**TOWN OF PORTOLA VALLEY
ARCHITECTURAL AND SITE CONTROL COMMISSION (ASCC)
Monday, November 10, 2014
Special Field Meeting (time and place as listed herein)
7:30 PM – Regular ASCC Meeting
Historic Schoolhouse
765 Portola Road, Portola Valley, CA 94028**

4. New Business:
 - a. Preliminary Architectural Review for a New Residence, Detached Garage, Guest House, Pool, and Site Development Permit X9H-681, 40 Antonio Court, Lands of Melton, File #: 44-2014 (Staff: D. Pedro)
 - b. Architectural Review for Residential Addition and Remodel, 125 Fawn Lane, Lands of Huffman, File #: 45-2014 (Staff: C. Borck)
 - c. Architectural Review for Garage Storage Addition/Remodel, 191 Ramos Road, Lands of Mumford, File # 42-2014 (Staff: C. Borck)
 5. Commission and Staff Reports:
 6. Approval of Minutes: October 27, 2014
 7. Adjournment:
-

TO: ASCC
FROM: Debbie Pedro, Planning Director
Carol Borck, Assistant Planner
DATE: November 10, 2014
RE: Agenda for November 10, 2014 ASCC Meeting

View from Master Bedroom window

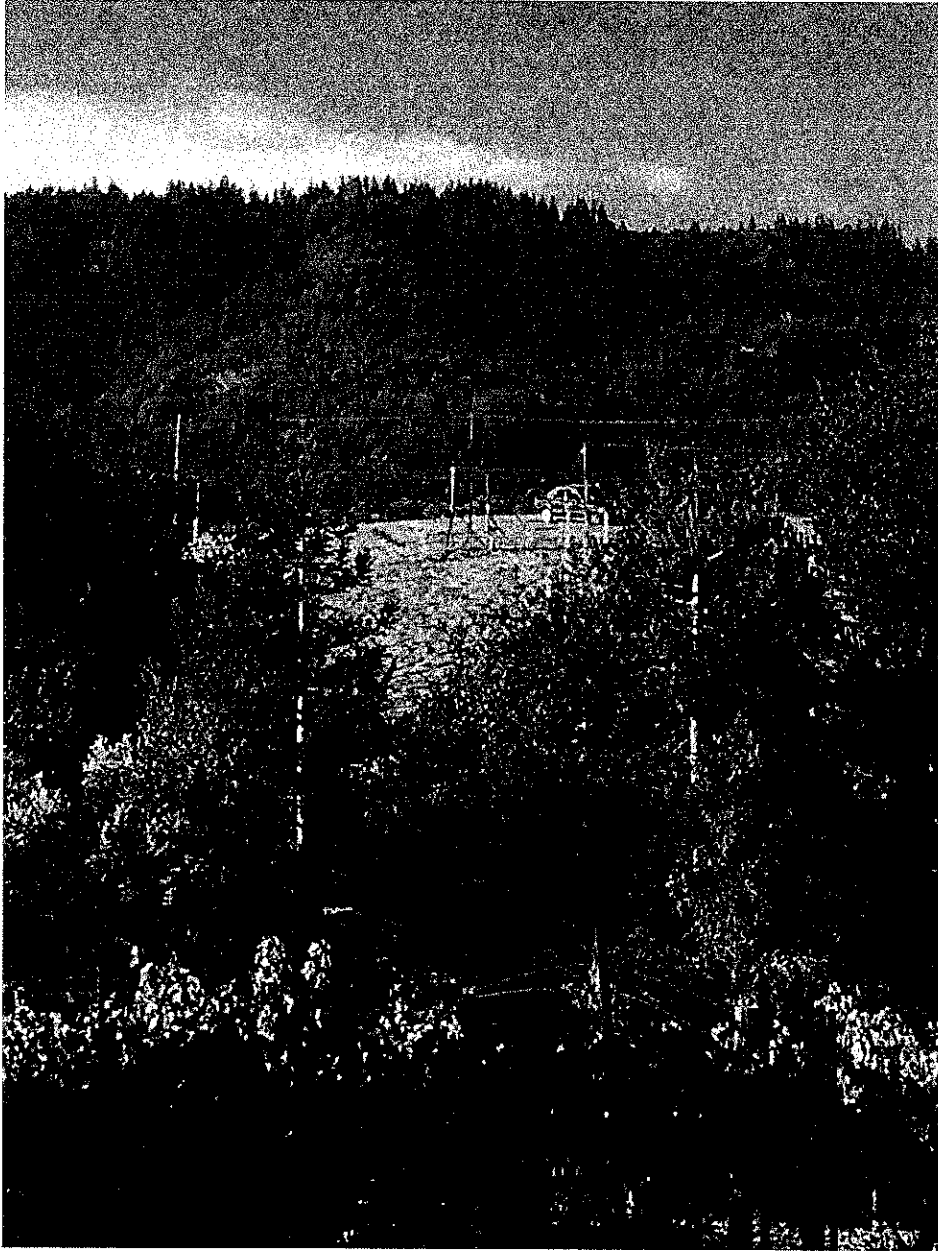
- Move the primary building towards Portola Road on the other side of the knoll – this would be consistent with the plans approved by the ASCC for the previous owner (Bob Larsen)

- Move the primary building off the top of the knoll so that it does not dominate the site.
- Dig down deeper than currently planned (e.g. another 10 feet) into the knoll so as to lower the roofline. This was again approved by the ASCC for the previous owner. The dug earth could also be used as a berm to screen the house.

- Change the architecture of the roof from an A frame to a flat roof. This would lower the roof line significantly and is consistent with the previously approved Larsen plan.

- Re-orient the house so that the longest length is perpendicular to Portola Road rather than parallel as currently envisioned. This is again along the lines of the previously approved Larsen plan.

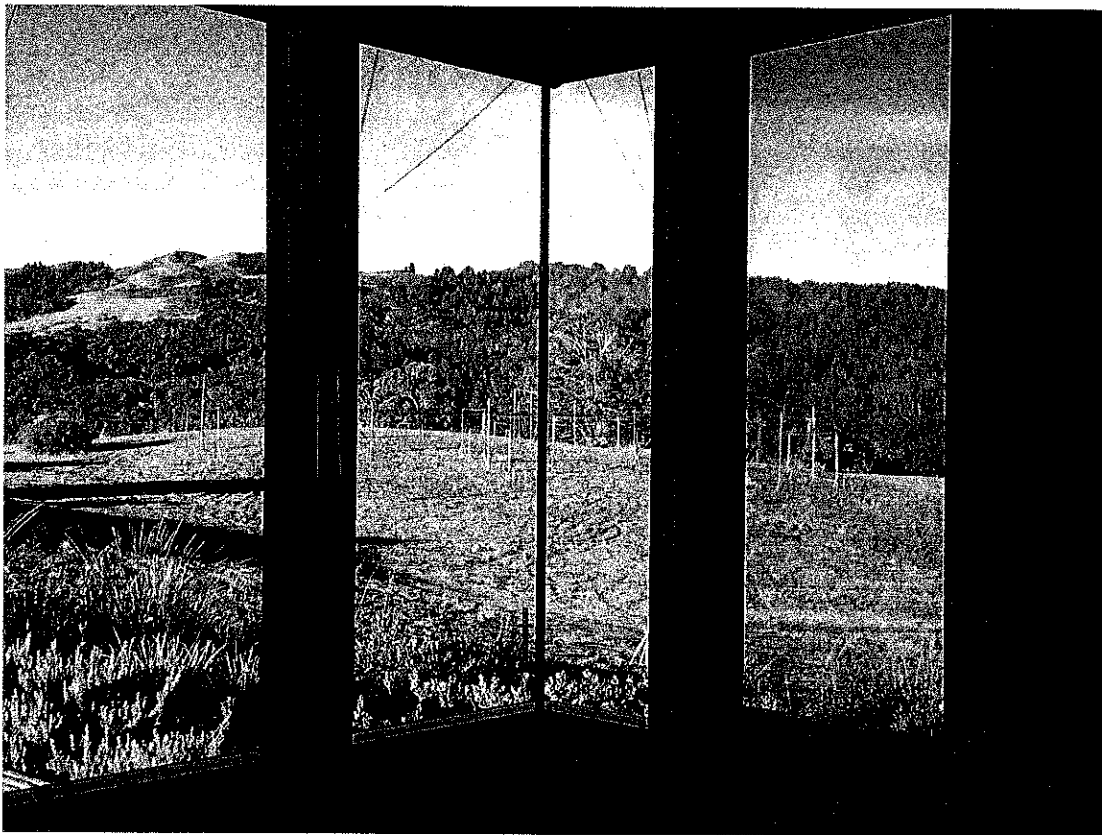
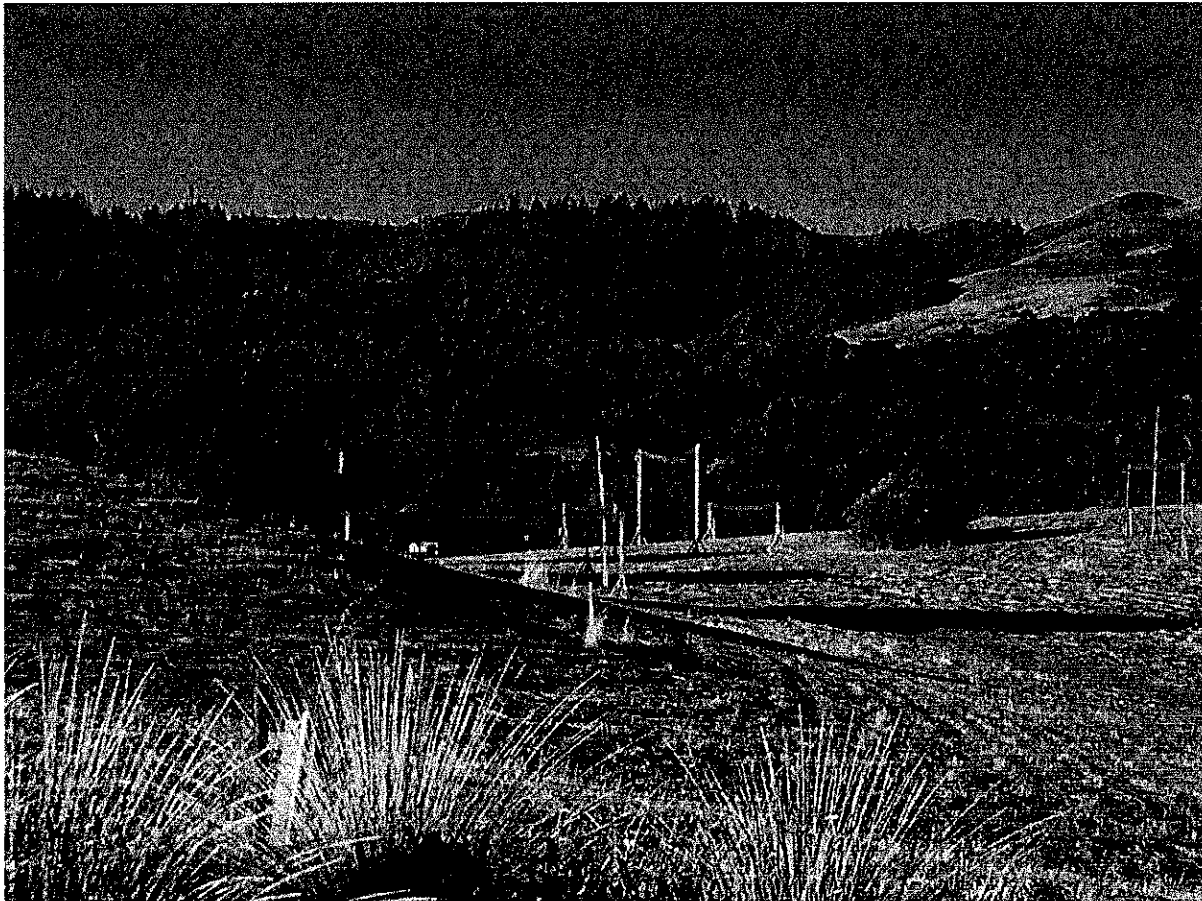
The main house is situated near the top of the knoll, substantially exceeds the height of the top of the knoll and extends across most of the top of the ridgeline. This placement seems inconsistent with the PV Design Guidelines regarding View Preservation ("Do not locate structures in visually prominent locations") and Ridgelines/Hilltops ("Keep rooflines of structures below the height of the existing tree canopy"). The mass of the main structure dominates the view of the hilltop on which it is situated and is impossible to screen.

The main structure also appears larger from our view because of the continuation of the "A" roof and wall over a covered patio area. From our perspective, this increases the apparent size of the house. Relocating this patio area closer to the pool, opening up the wall or flattening the roof would help to minimize the apparent mass of the house.

We were also surprised by the addition of 3 accessory buildings on the property, adding to the visual impact of the development. The additional garage and guesthouse structures also employ an "A" roof design. The impact of these structures could be lessened by digging down and modifying the roof design to be flatter.

Finally, we are very concerned about the presence of a standalone gate. The gate is situated very close to our master bedroom and our children's bedrooms, in which our windows are often open. The proximity creates concern about noise (from intercom, vehicles and opening and closing), exhaust from idling vehicles and lights that would be
